RESPONSE TO COUNCIL WITH RFI ITEM No.
- MODIFICATIONS RECOMMENDED BY CONSULTANTS / AUTHORITIES
- MODIFICATIONS RECOMMENDED BY BAYSIDE DESIGN REVIEW PANEL 5 MAY 2022

SECTION 4.56 APPLICATION

2 BOURKE STREET (FORMERLY 653 GARDENERS ROAD) MASCOT

PROJECT
Bourke Street
Mixed-Use

MODIFICATION CHANGES - SITE PLAN

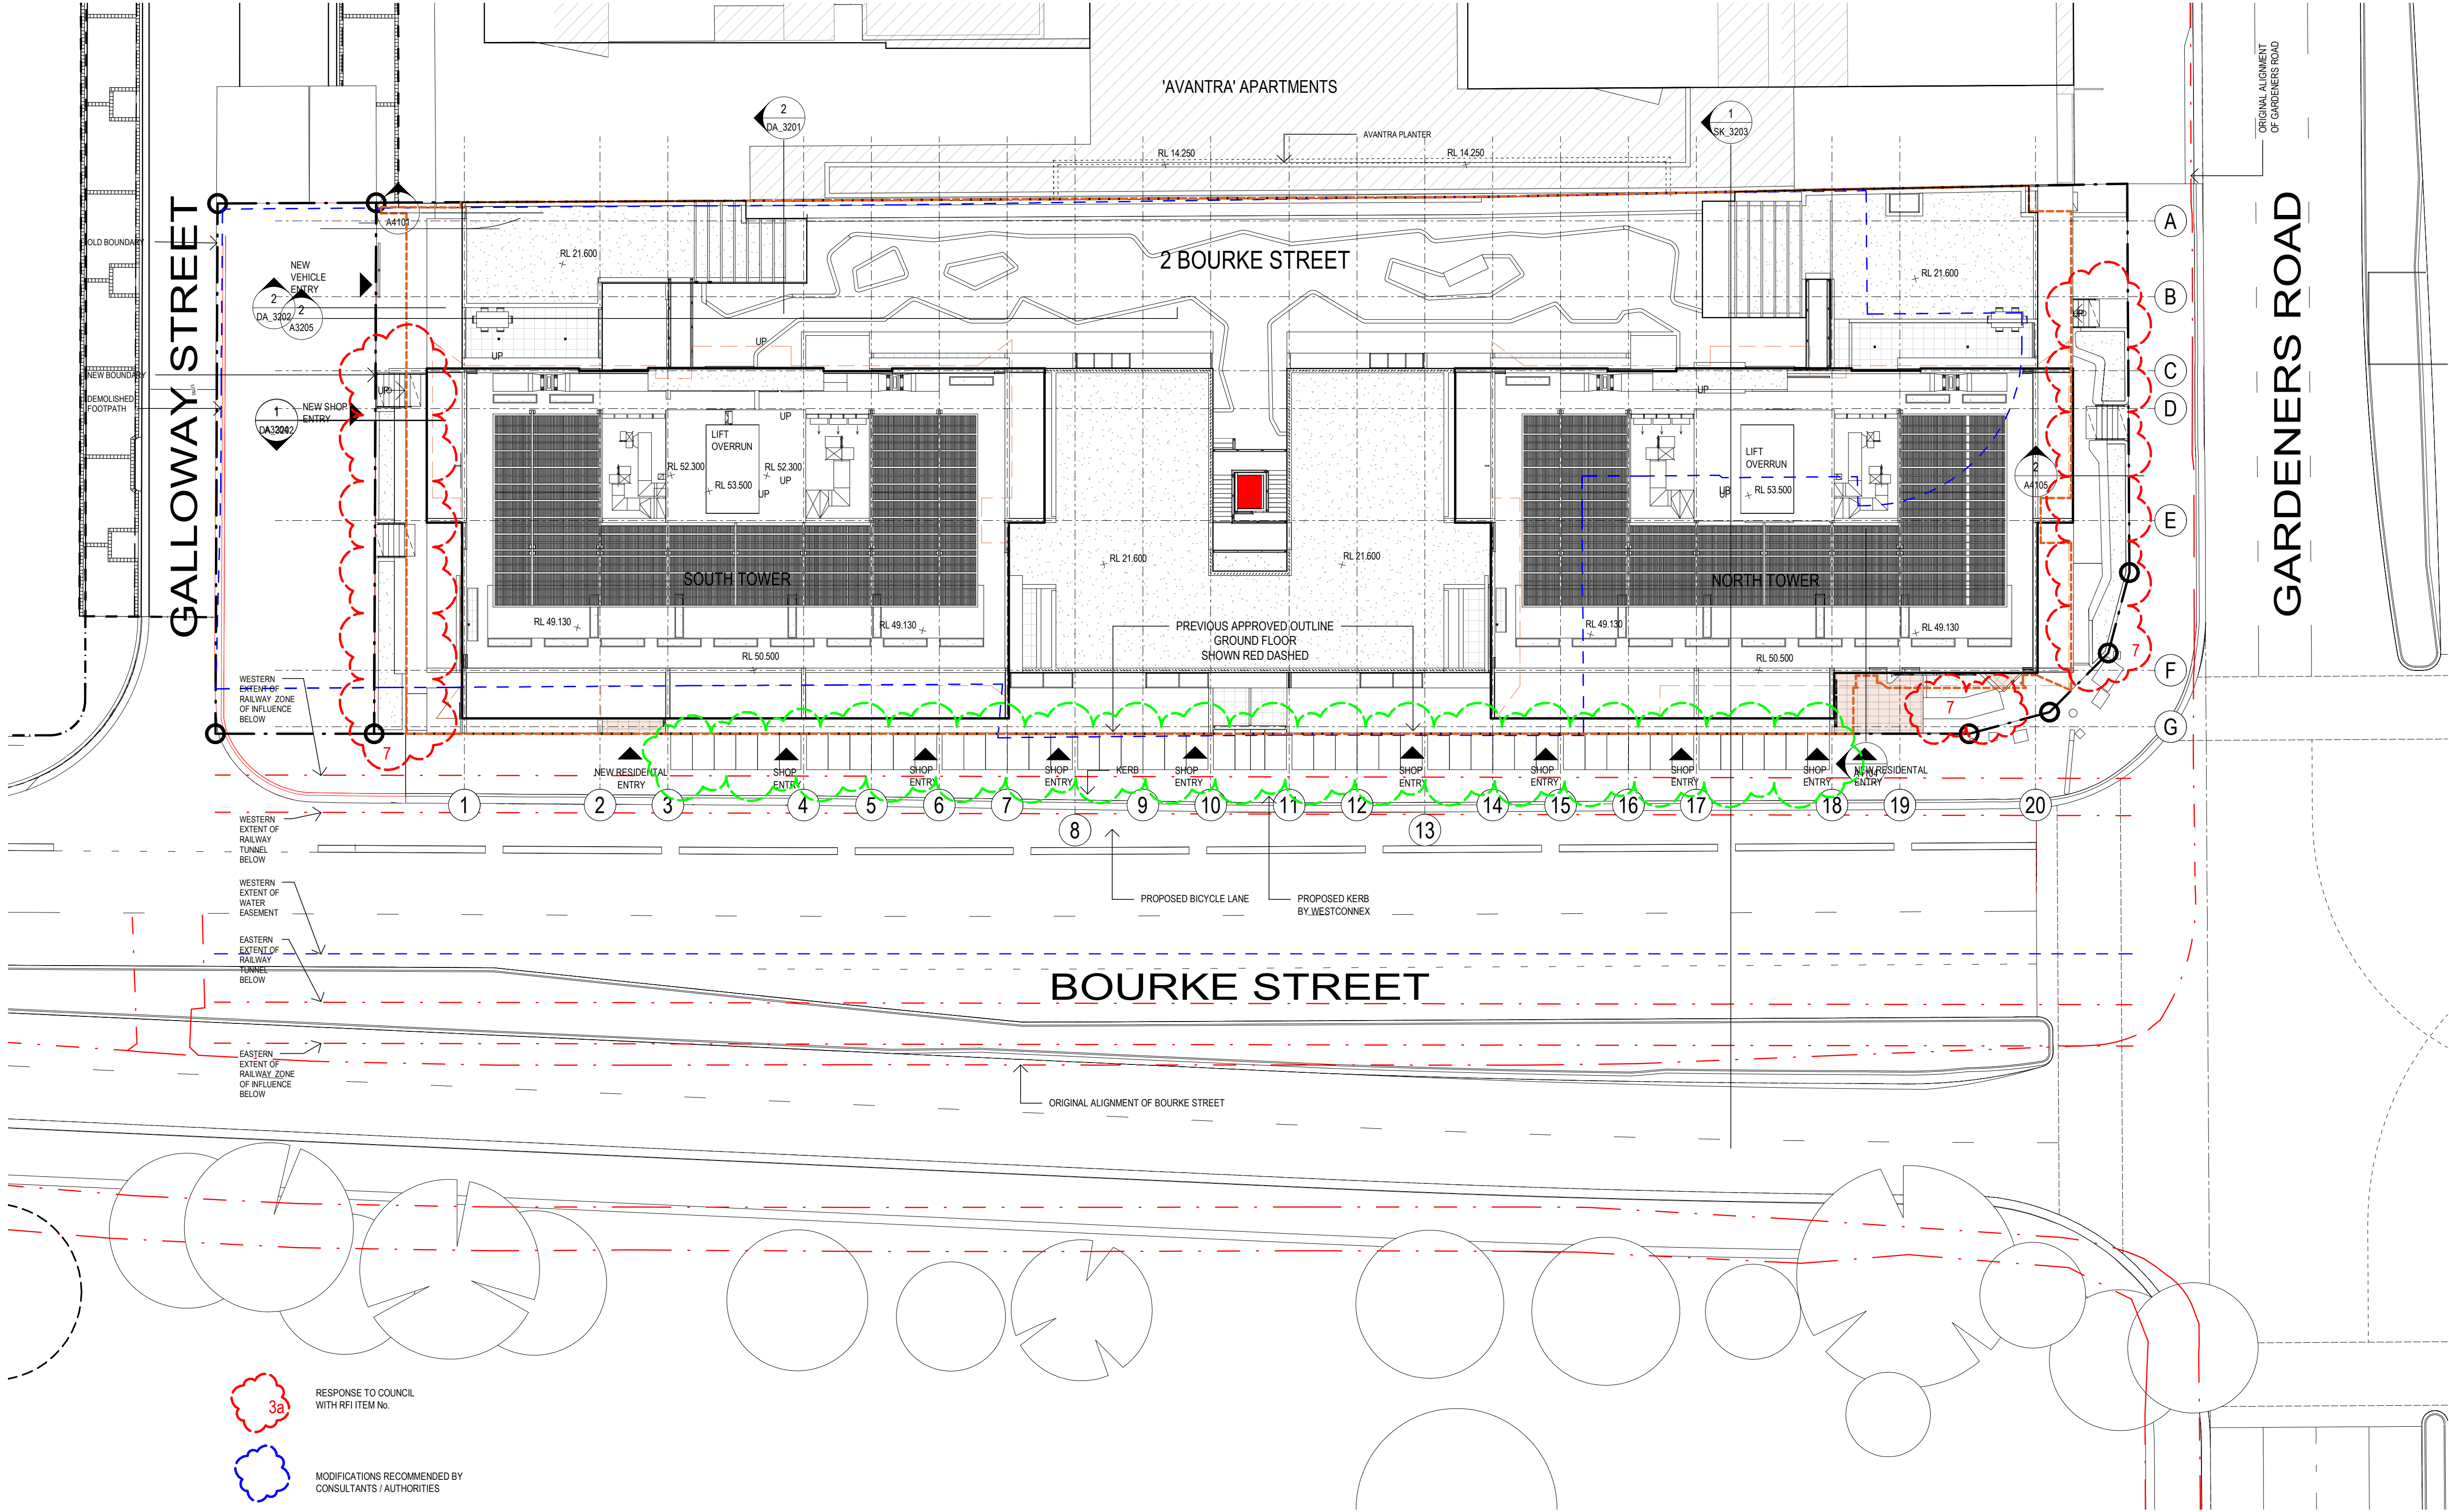
MODIFICATION CHANGES - NORTH-EAST VIEW	
DESCRIPTION	REASON FOR CHANGE
- RAISED PLANTER BED WALLS INTERFACING PUBLIC DOMAIN MAX 450mm HEIGHT - ARTWORK TO FIRE HYDRANT BOOSTER ENCLOSURE - FACADE DESIGN DEVELOPMENT - PRECAST PANELS TO CARPARK - HORIZONTAL ARTICULATION INCORPORATED - SHOPFRONT AWNINGS EXTENDED OVER FOOTPATH	REQUESTED BY COUNCIL REQUESTED BY COUNCIL MODIFICATIONS RECOMMENDED BY BAYSIDE REVIEW PANEL 05 MAY 2022

SHEET TITLE
SITE PLAN

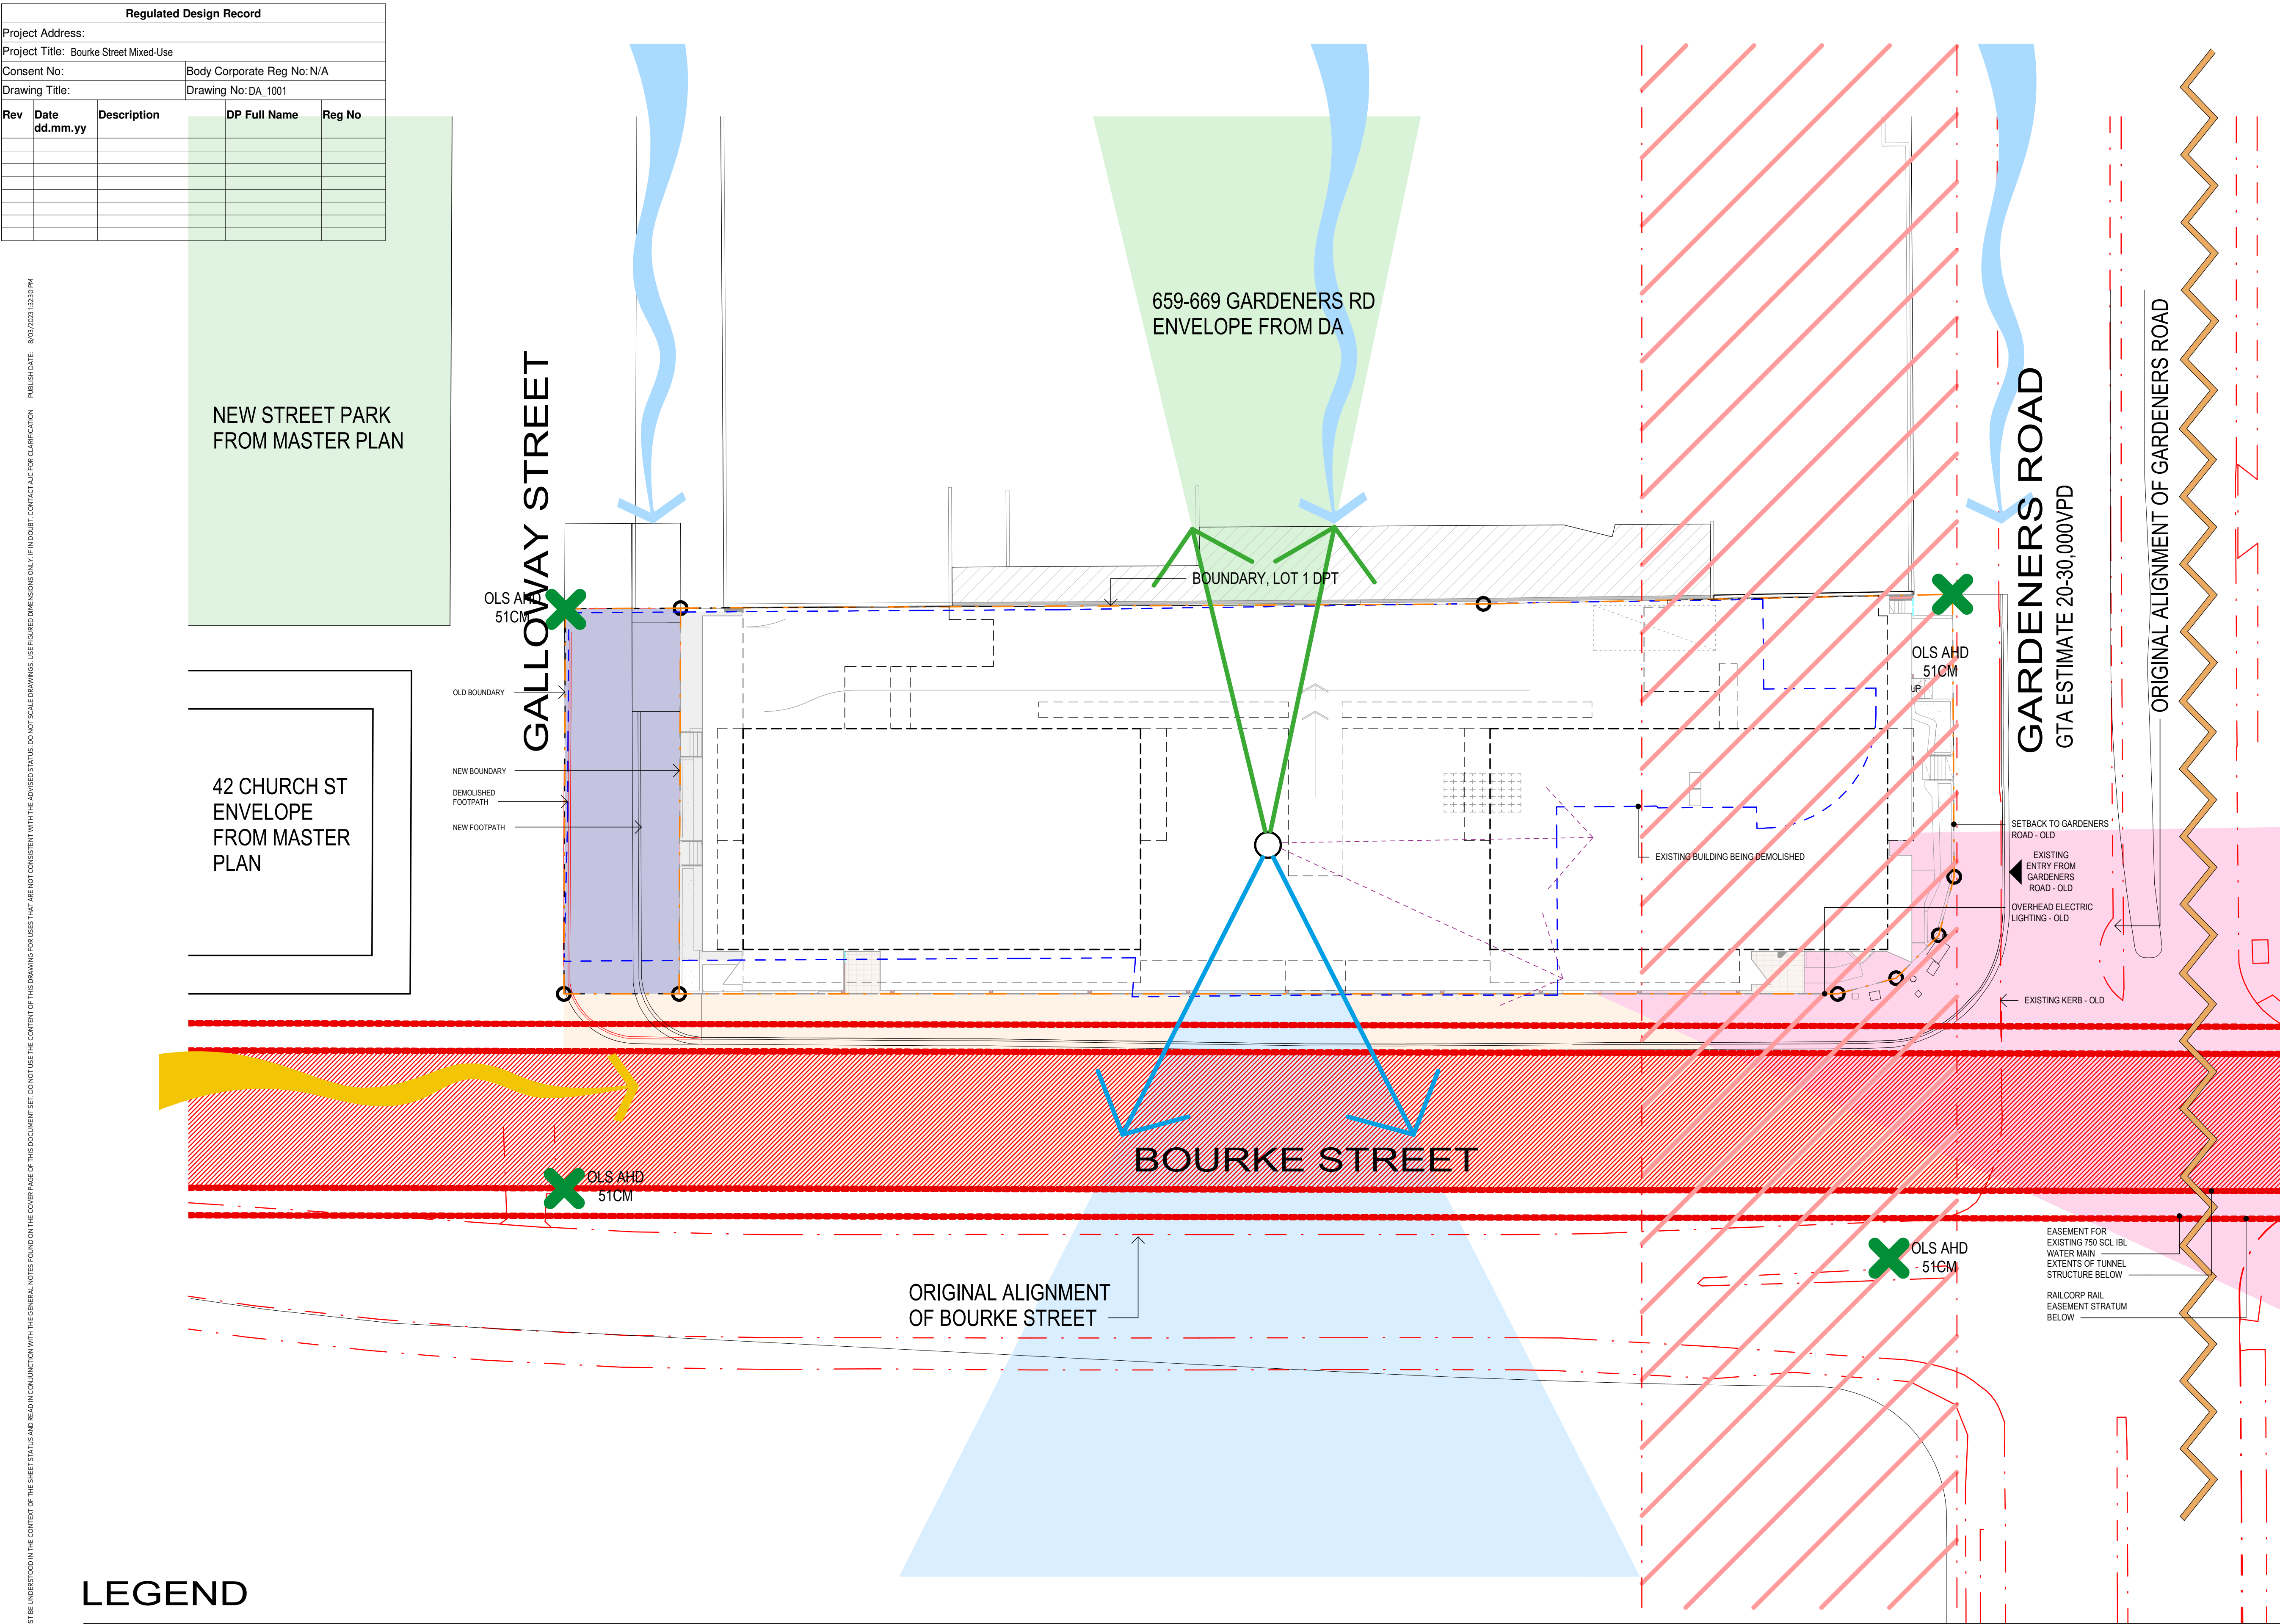
DESCRIPTION	REASON FOR CHANGE
- RAISED PLANTER BED WALLS INTERFACING PUBLIC DOMAIN MAX 450mm HEIGHT - FACADE DESIGN DEVELOPMENT - SHOPFRONT AWNINGS EXTENDED OVER FOOTPATH	REQUESTED BY COUNCIL MODIFICATIONS RECOMMENDED BY BAYSIDE REVIEW PANEL 05 MAY 2022

1 MEZZANINE LEVEL PLAN 1:200

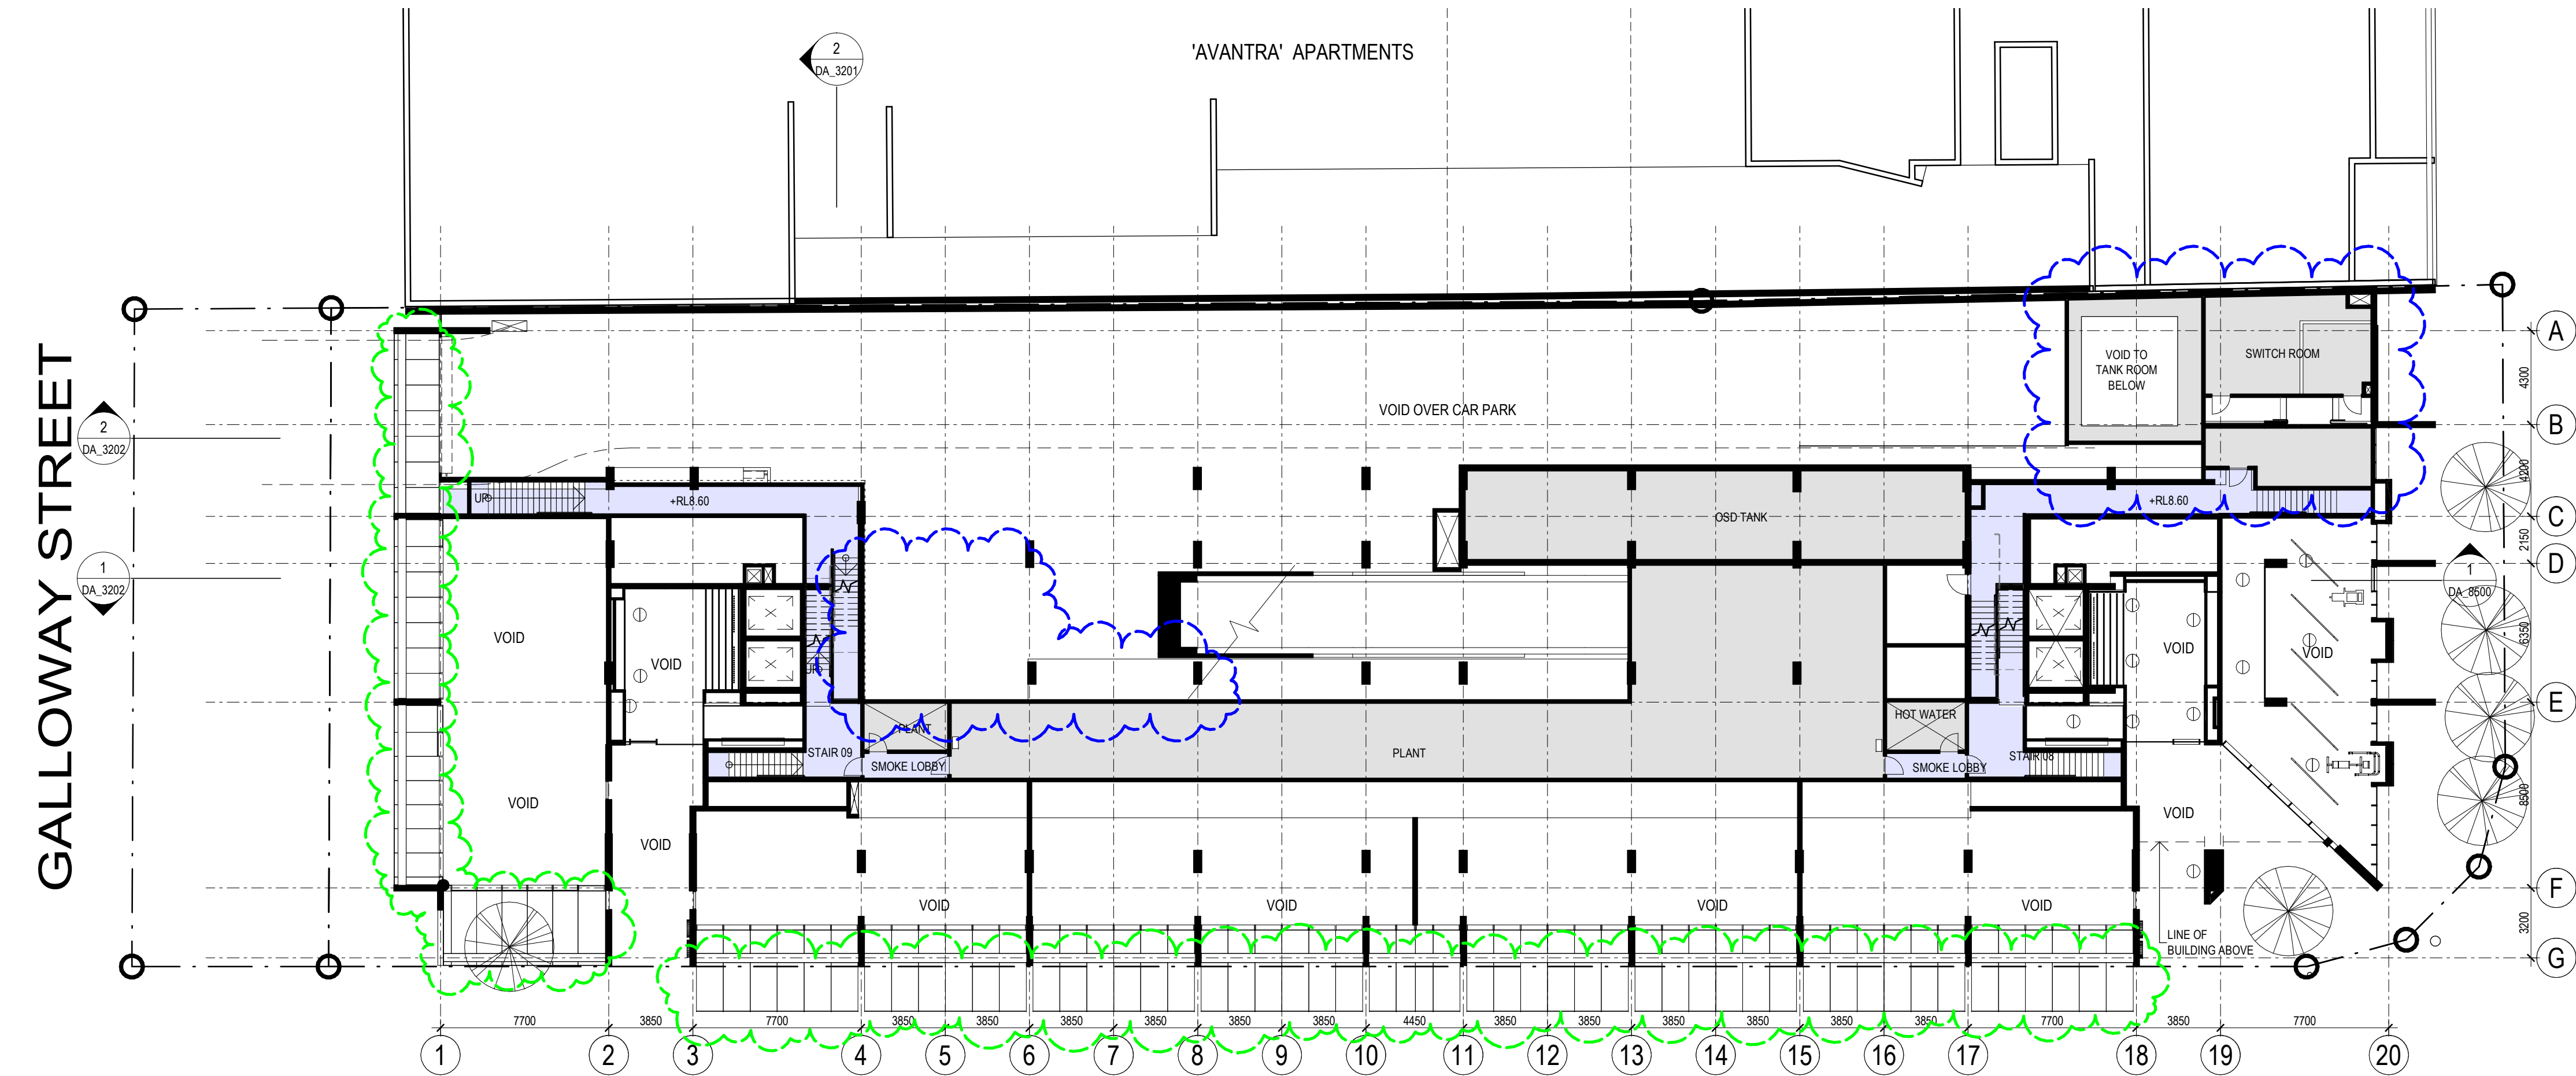
DESCRIPTION	REASON FOR CHANGE
- HYDRANT TANK AND SWITCH ROOM RELOCATED - FLOOR SLAB ABOVE LOADING DOCK DELETED - FACADE DESIGN DEVELOPMENT - SHOPFRONT AWNINGS EXTENDED OVER FOOTPATH AND PRIVATE DOMAIN	REQUESTED BY STRUCTURAL / ELECT ENGINEERS REQUESTED BY TRAFFIC ENGINEER MODIFICATIONS RECOMMENDED BY BAYSIDE REVIEW PANEL 05 MAY 2022
